**ADDENDUM NO. 2
TO THE CONTRACT DOCUMENTS
for the construction of the
Ozone Biofiltration System
(UOSA Contract OBF)
Upper Occoquan Service Authority**

ADDENDUM NO. 2
to the
CONTRACT DOCUMENTS
for the construction of
Ozone Biofiltration System
UOSA Contract OBF
Upper Occoquan Service Authority
Centreville, VA

Date: January 18, 2024

FILTER EFFLUENT PUMP STATION
PLAN
1/4" = 1'-0"

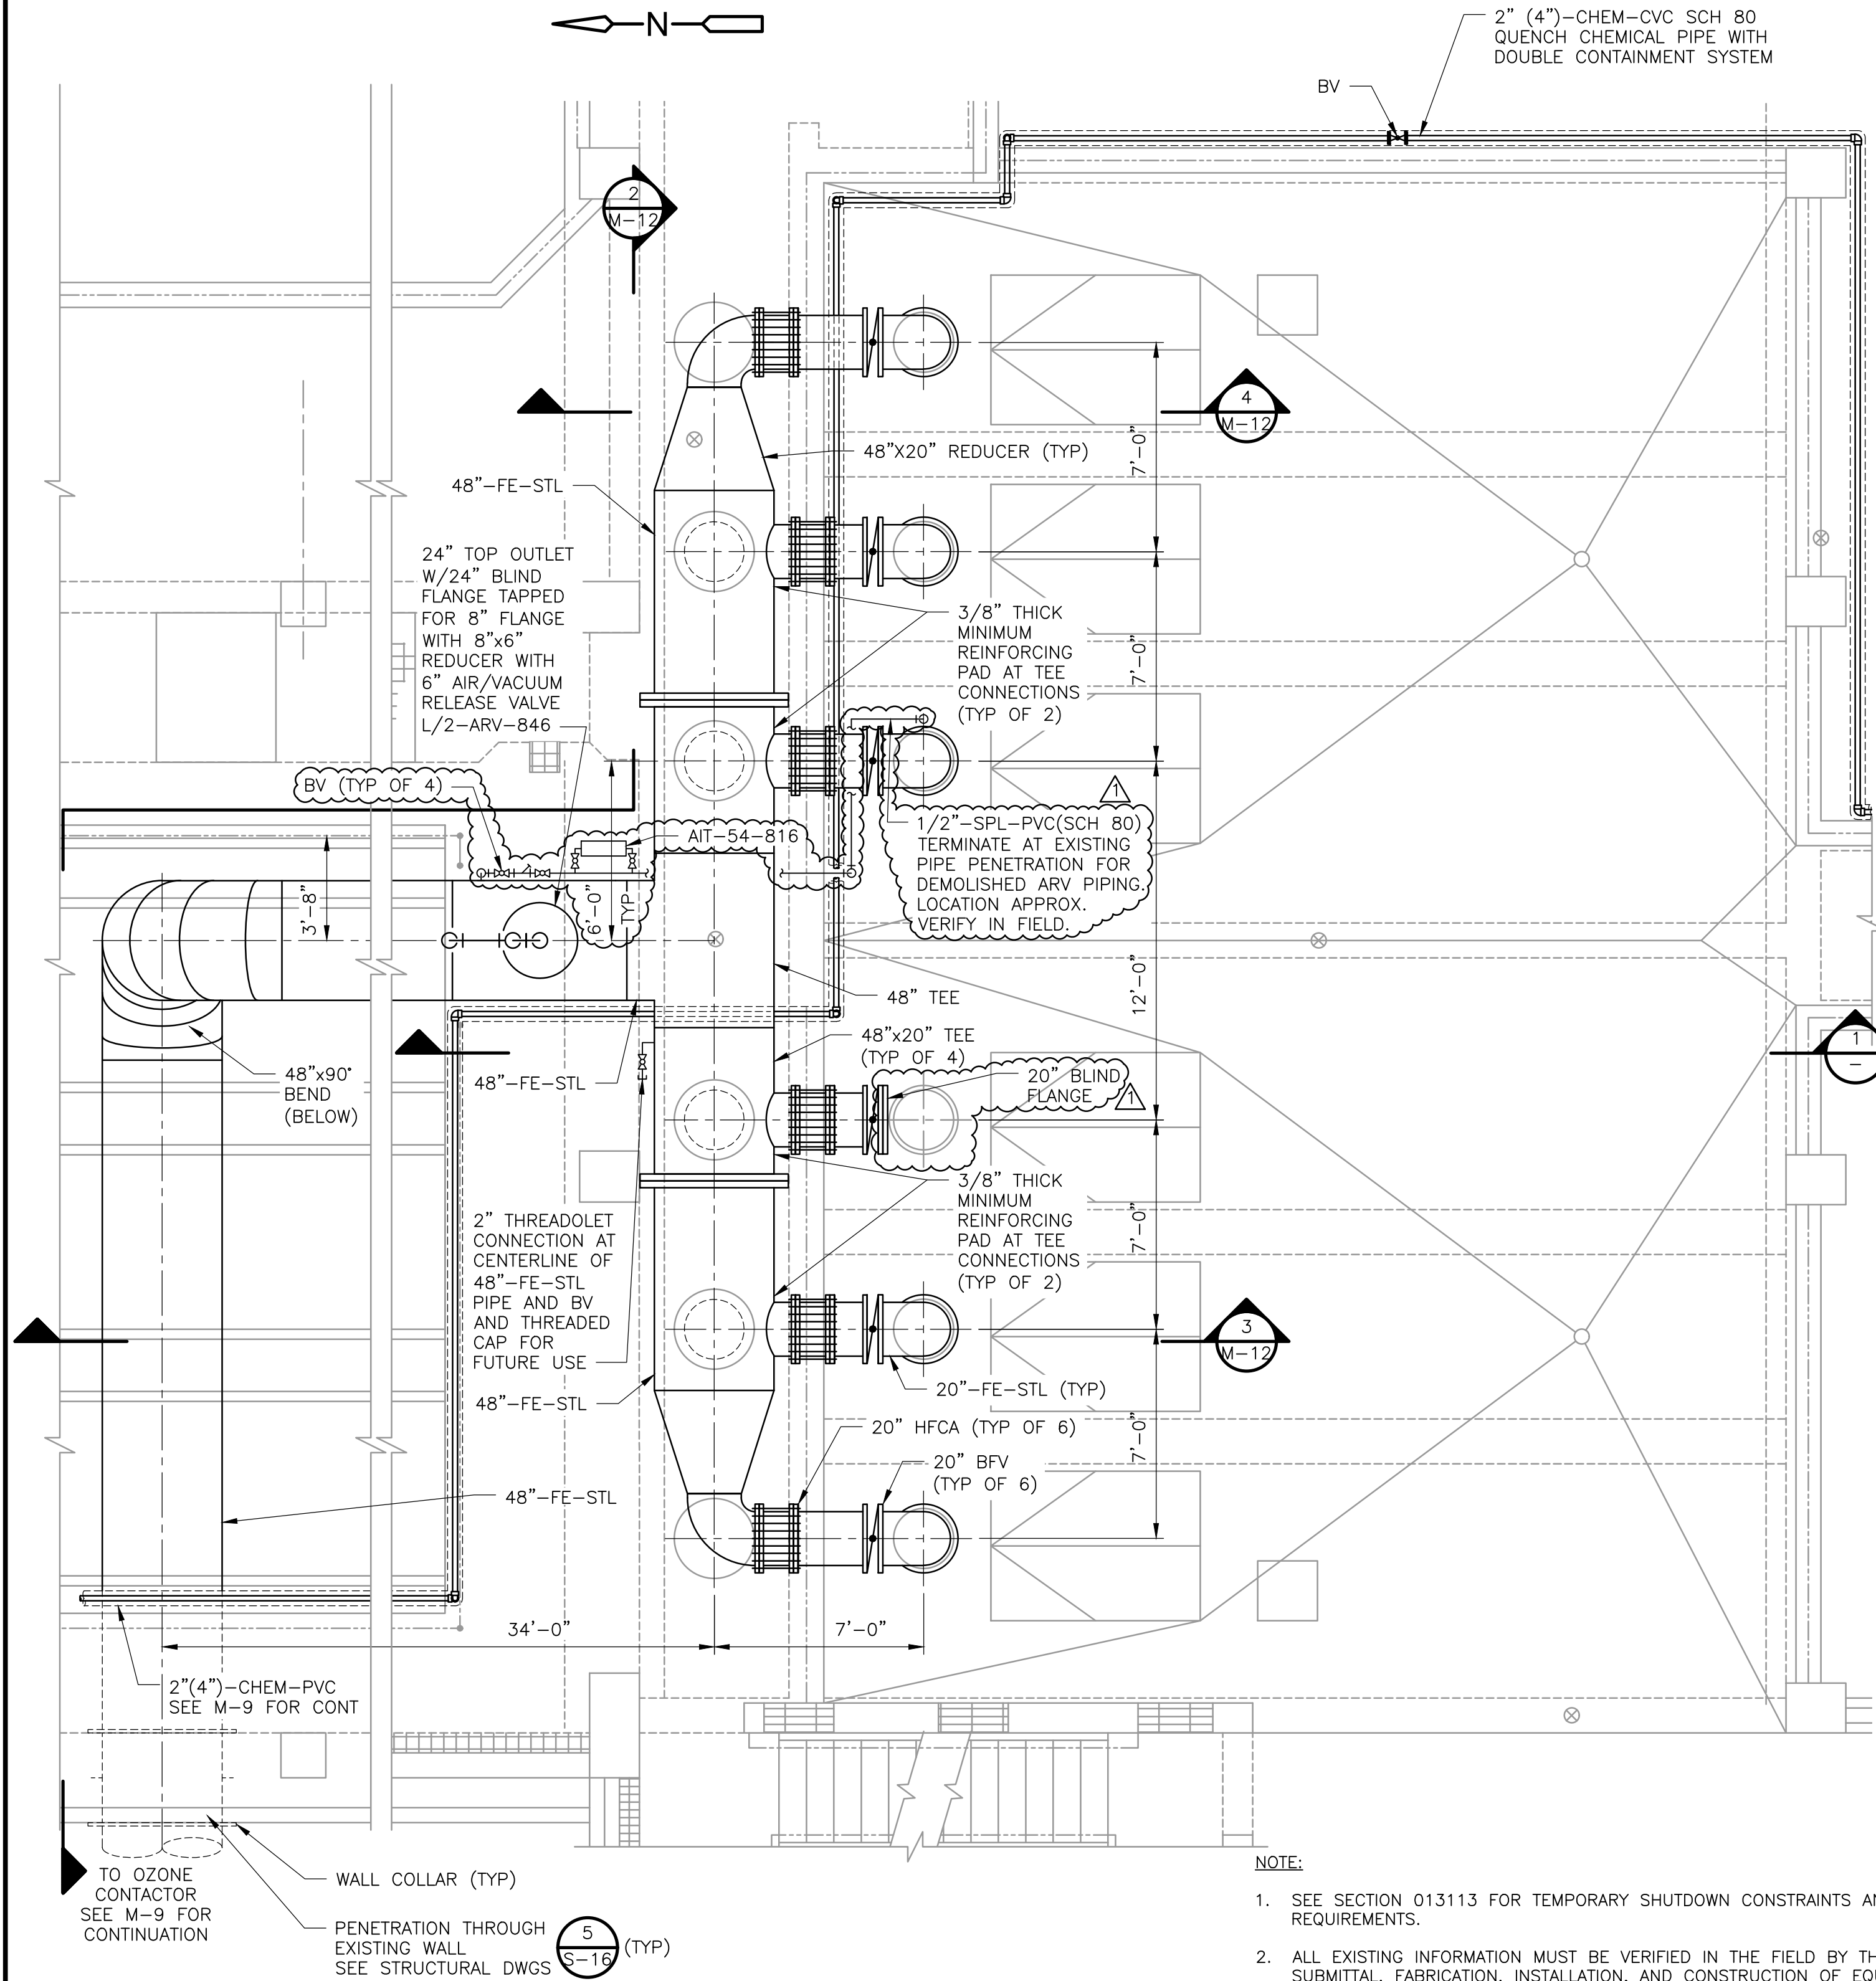
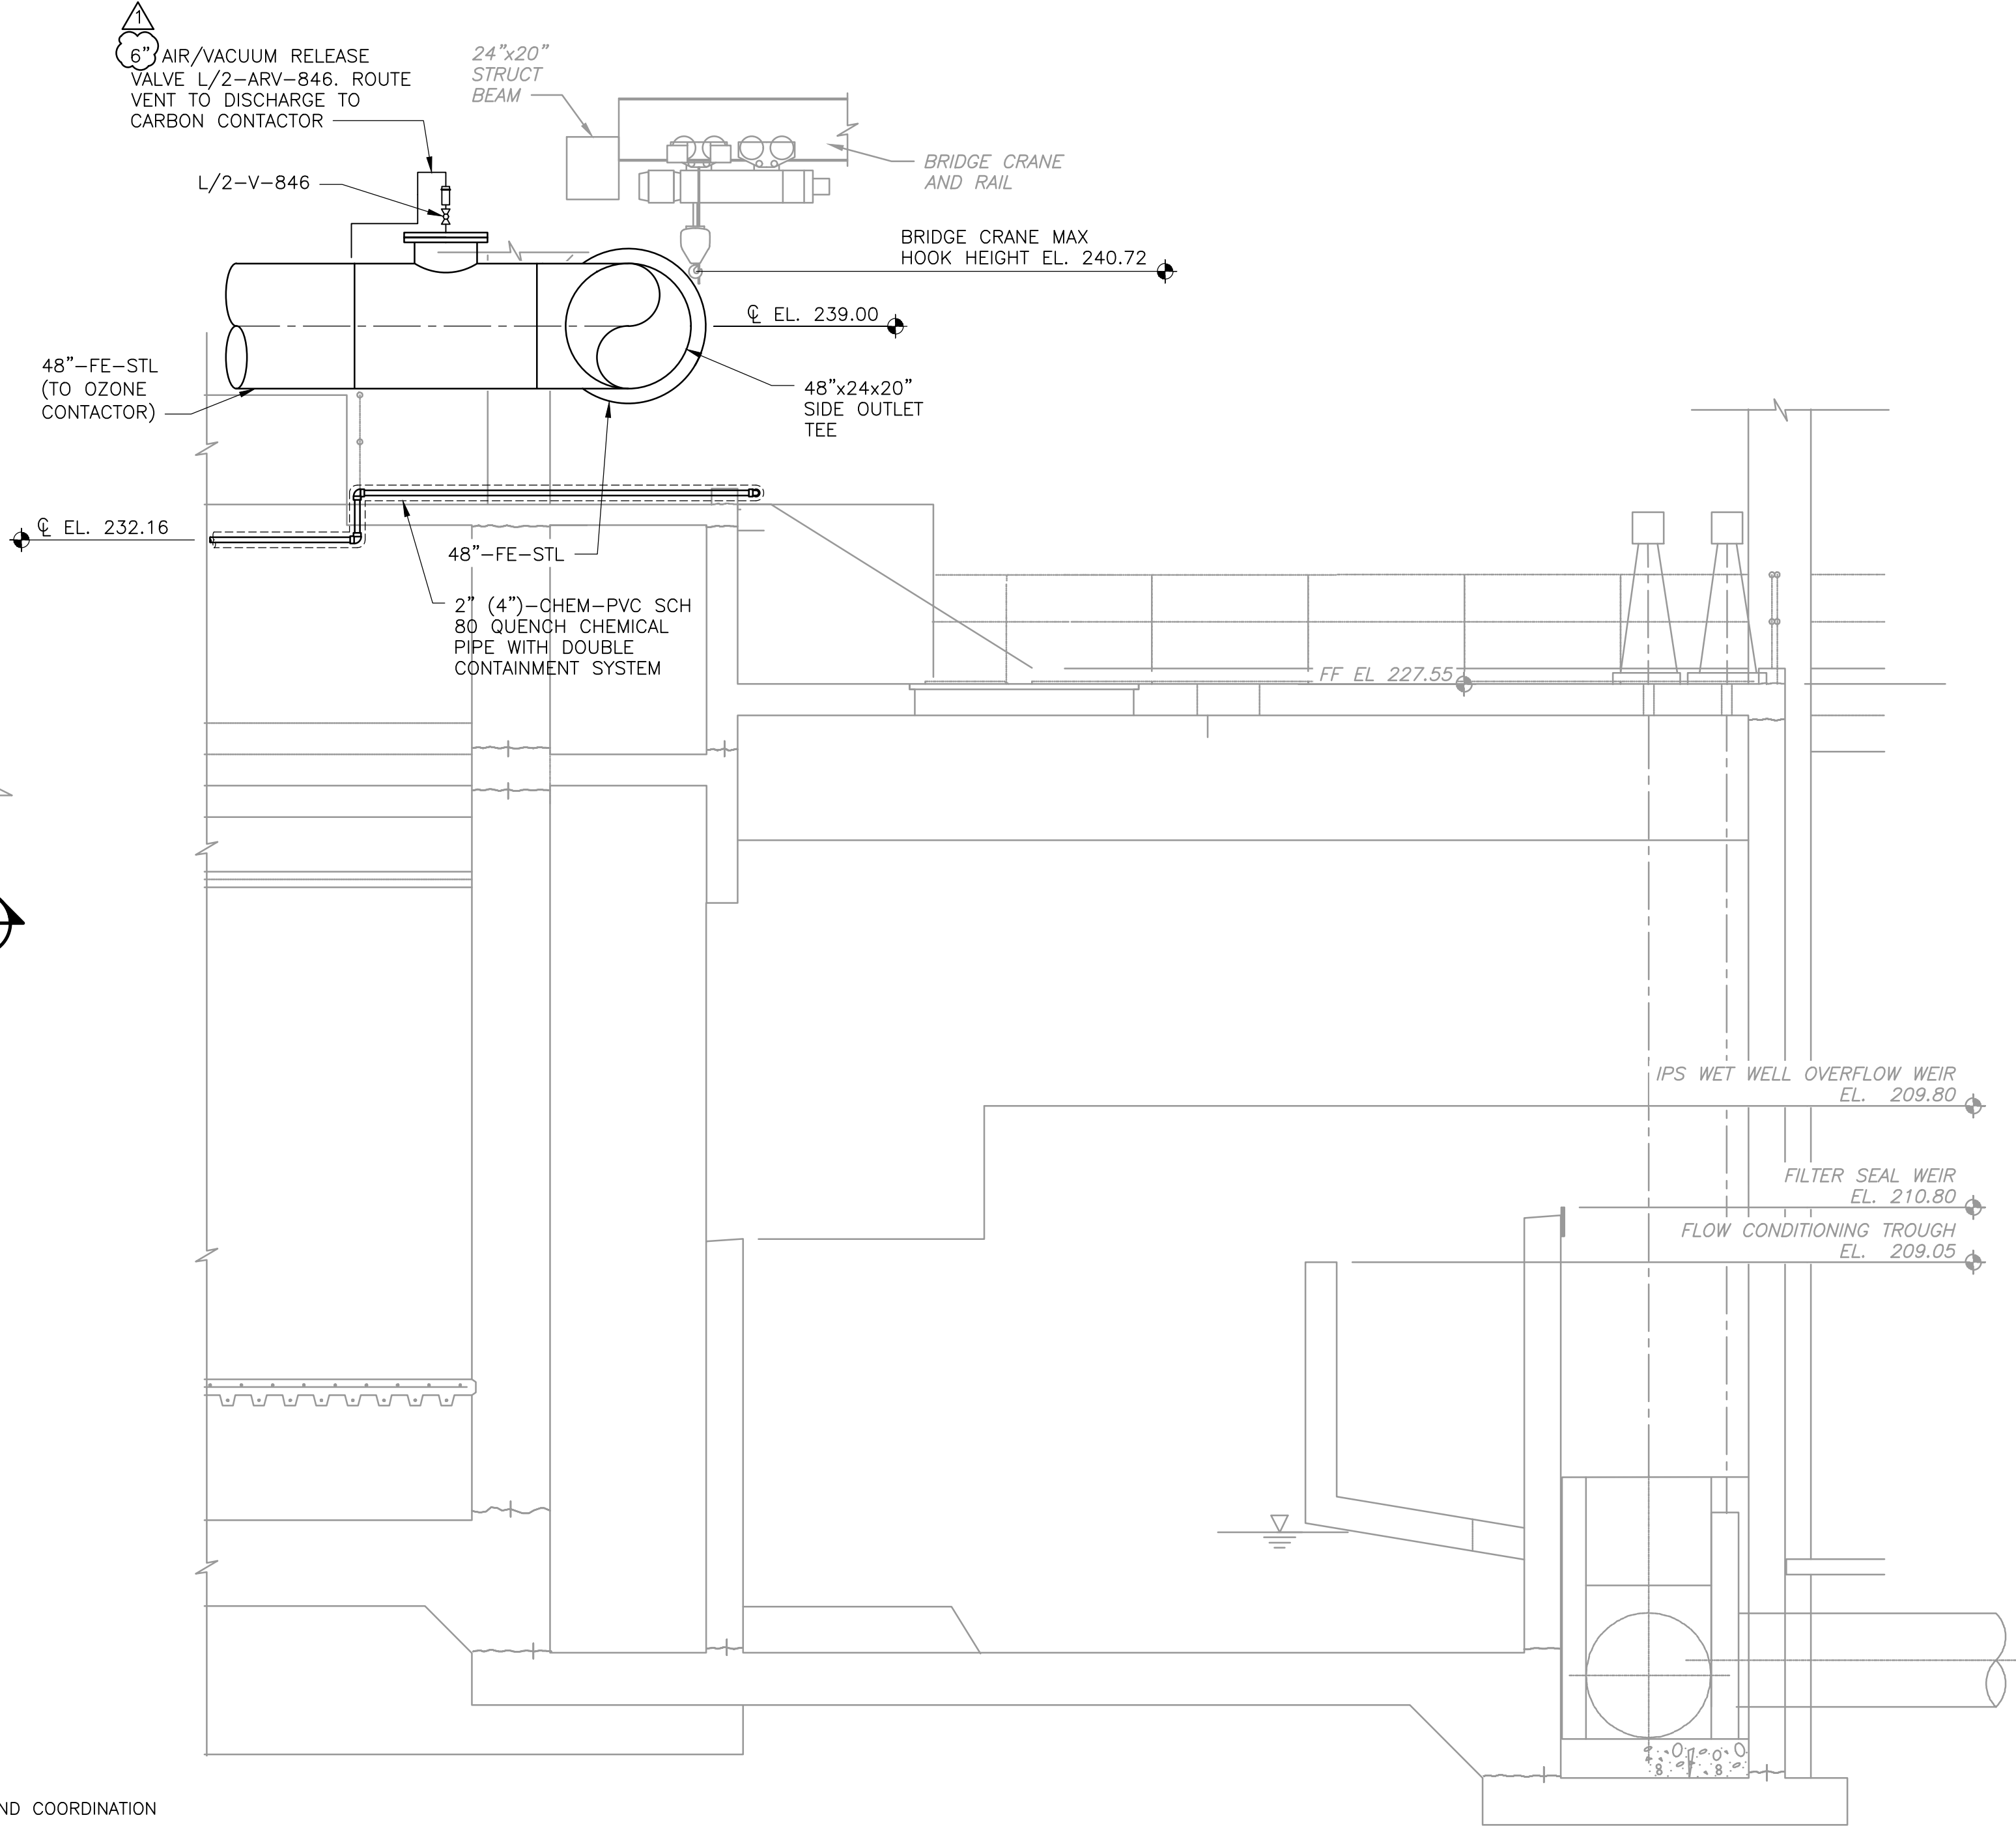
REV. NO.	DATE	DRWN	CHKD	REMARKS
1	12/23	MAR	BWZ	ADDENDUM 2. REVISED ARV SIZE
